**TOWN OF WELLINGTON
PLANNING COMMISSION**

Date: September 14, 2020
Submitted By: Cody Bird, Planning Director
Subject: Preliminary Plat of Sage Meadows Second Subdivision

Date: September 14, 2020
Submitted By: Cody Bird, Planning Director
Subject: Site Plan Review: Lot 4, Wellington Business Center

1 ENLARGED SITE PLAN
1" = 20'-0"

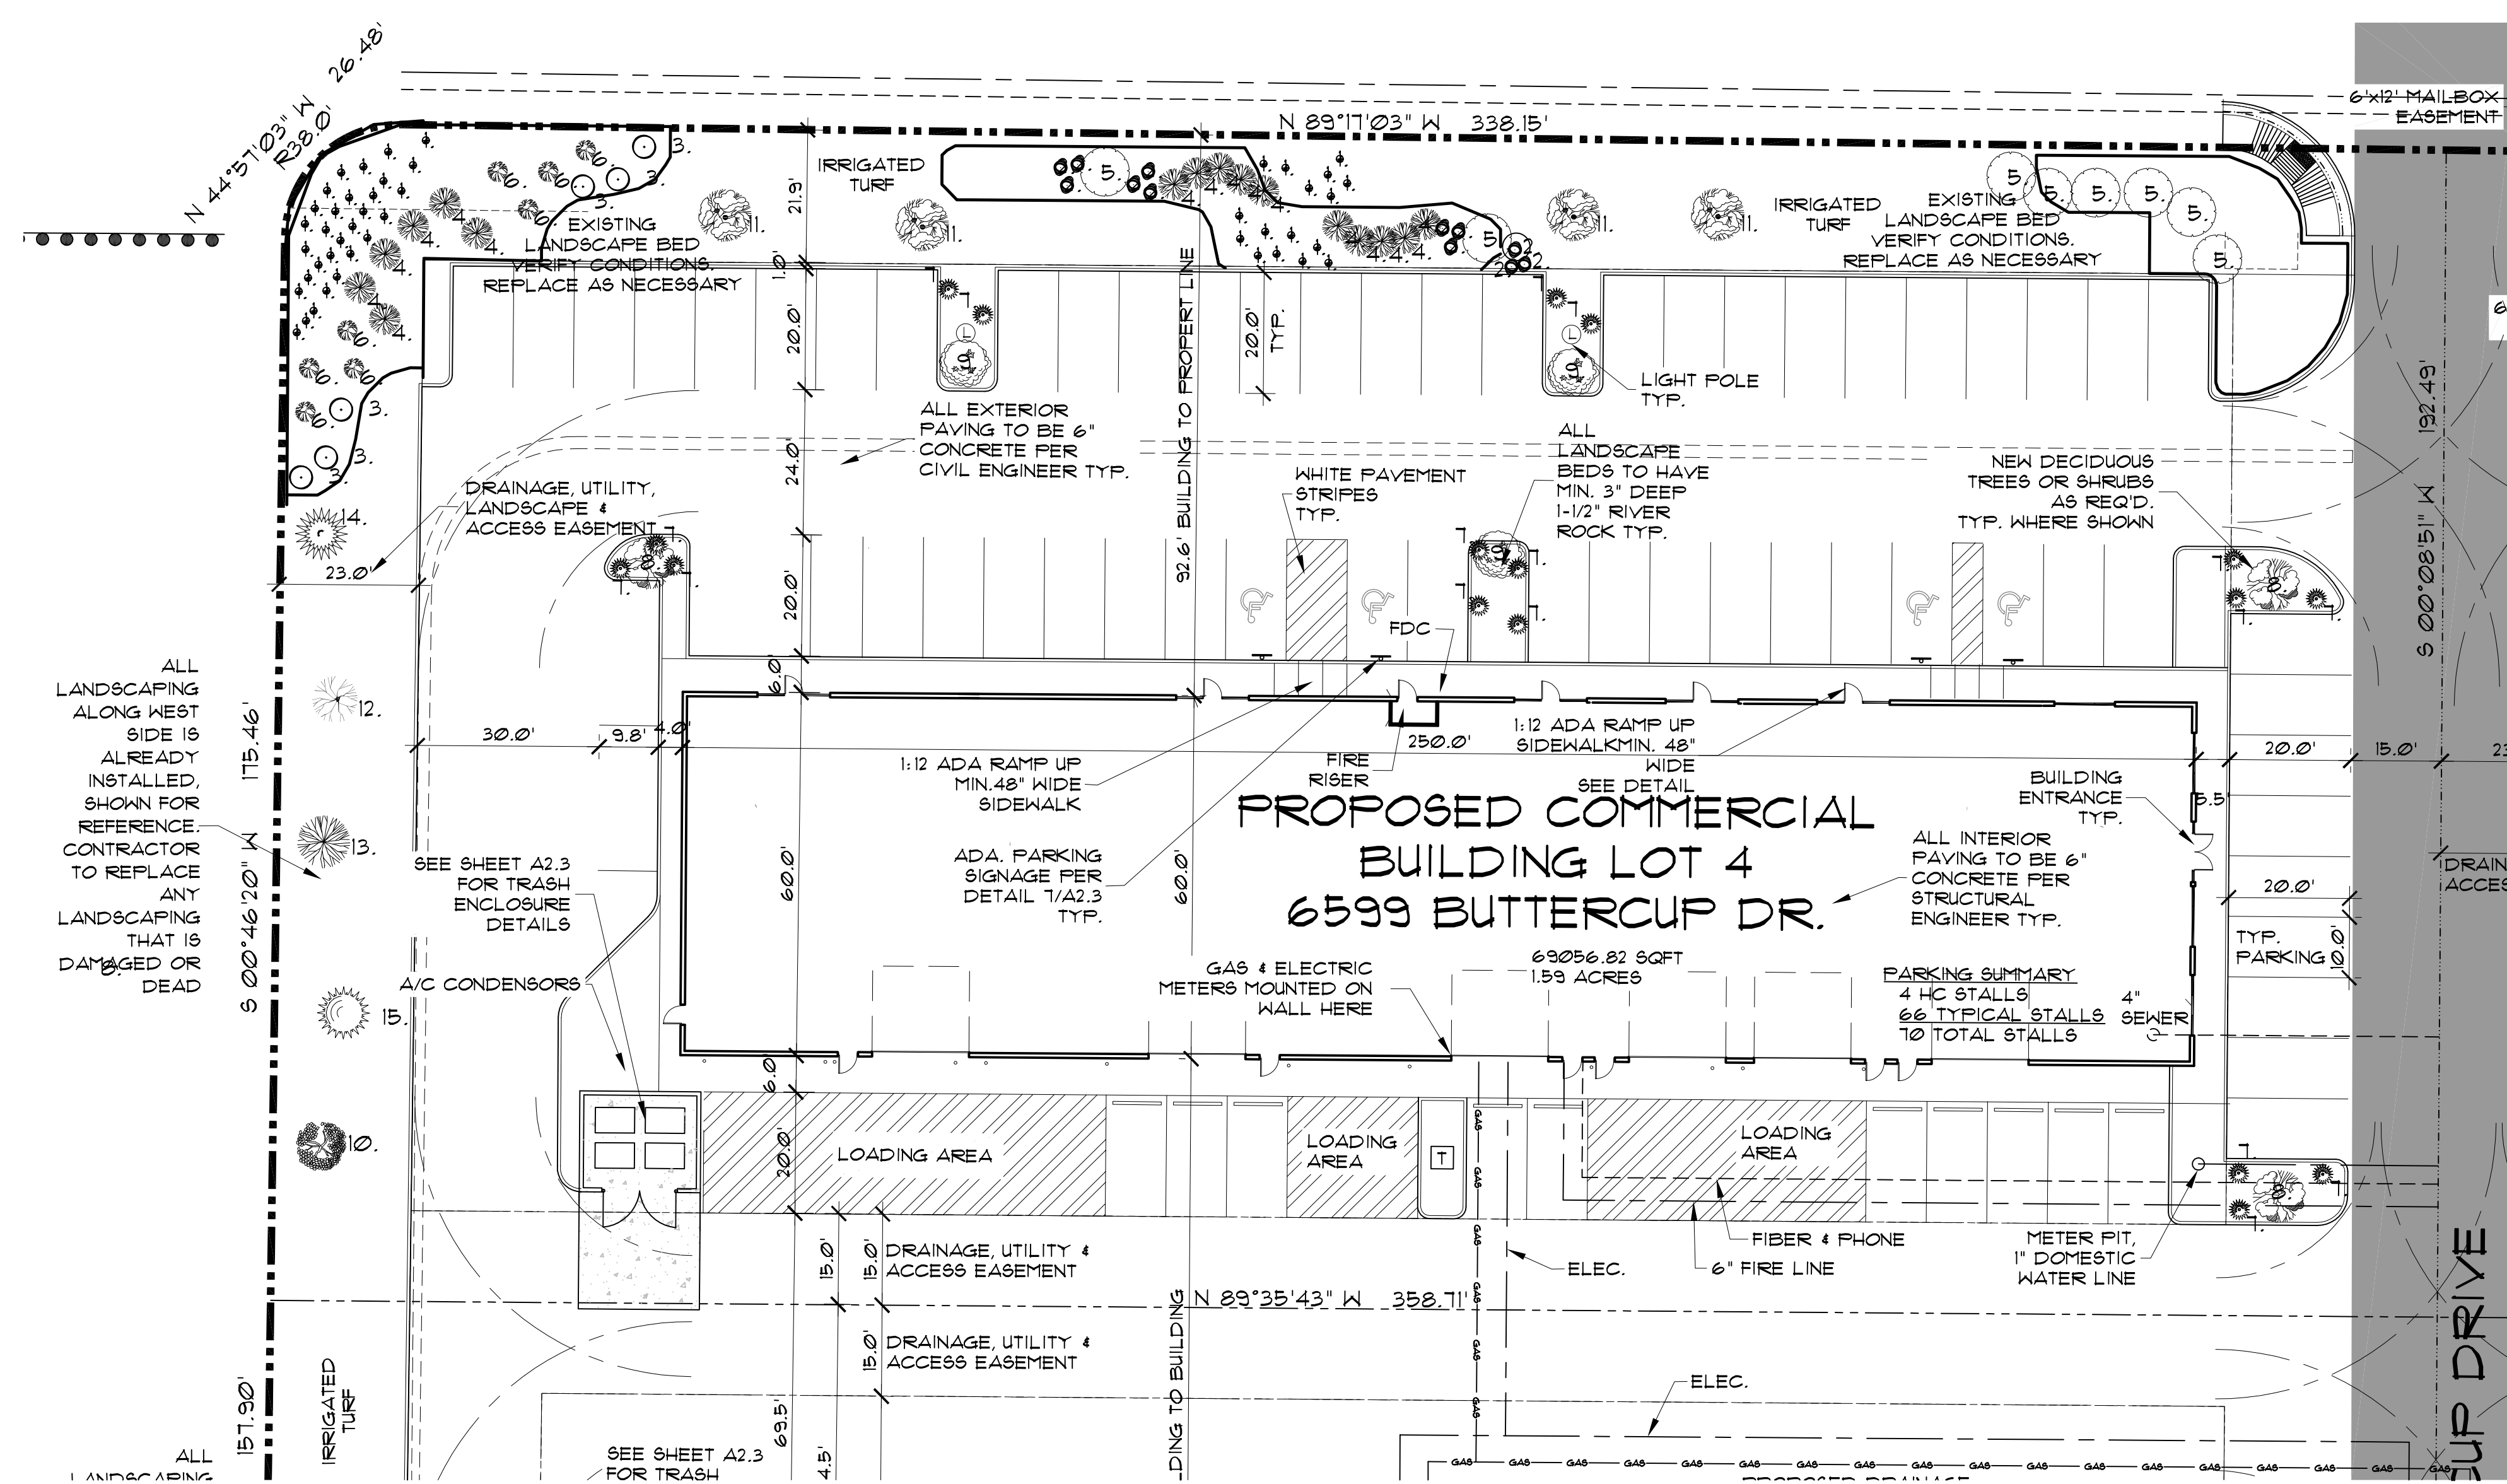
5. Parking: A sufficient number of parking spaces are proposed to satisfy the off-street parking requirement.
 - Most parking spaces meet the minimum width and depth requirement (10 ft. x 20 ft.) as required. Some parking spaces on the civil engineering plans are shown to be 9 ft. in width, which is less than the minimum. The civil plans and architectural plans need to be coordinated for accuracy.

- There are no bicycle racks identified on the site plans. A bicycle rack shall be provided at each building within the development. Proposed locations shall be identified on the revised site plans.

- Van accessible parking spaces are required to be minimum of 11 ft. in width. The civil site plans show ADA parking spaces at less than the 11 ft. width and needs to be updated on the revised plan sets.

2 RAMP DETAIL
3" = 1'-0"

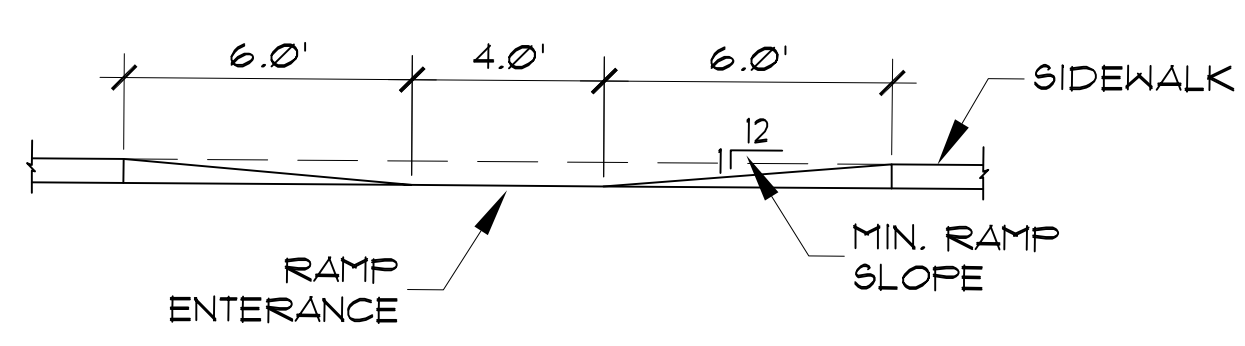
- ADA signage is required to be a minimum of 60 inches above grade to the bottom of the sign face. The details in the site plans need to be updated to reflect the sign height requirement.
